Service Letter No. 417

SUBJECT: Replacement of Fuel Injector Inlet Screens

MODELS AFFECTED: PA-30 Twin Comanches, Serial No. 30-1 to 30-179 incl.
30-180 right engine only
30-181 left engine only
30-202 right engine only
30-220 right engine only

Service Letter 417

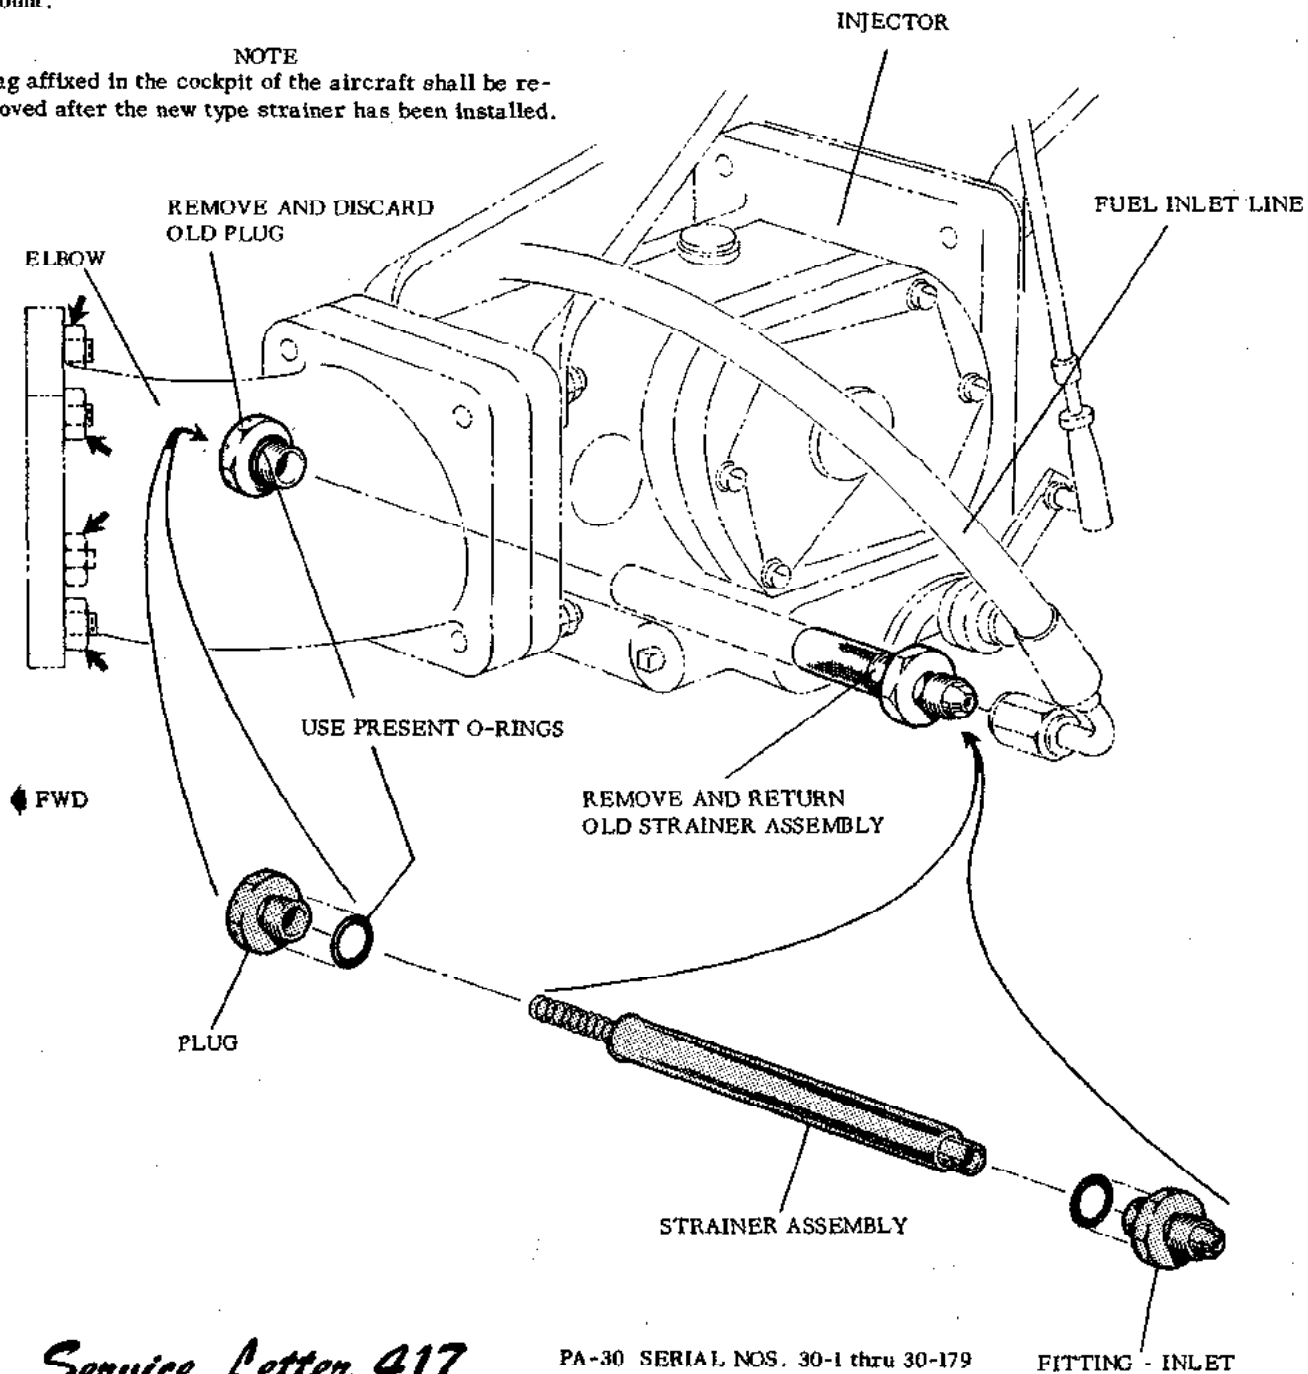
The fuel injector inlet screen installed as original equipment in the subject aircraft is difficult to remove and install during routine inspection.

A fuel injector inlet screen replacement kit, part number 756 782, consisting of two fuel inlet fittings, two strainer assemblies and two plugs, which will facilitate removal and installation, is now available and shall be installed at or before the next 100 hour inspection in accordance with the sketch on the reverse side of this letter.

Loosen the four nuts holding the 45° injector turning elbow to the engine oil sump sufficiently to allow the downward rotation of the injector assembly so that the screen assembly will pass freely below the engine mount.

Tag affixed in the cockpit of the aircraft shall be removed after the new type strainer has been installed.
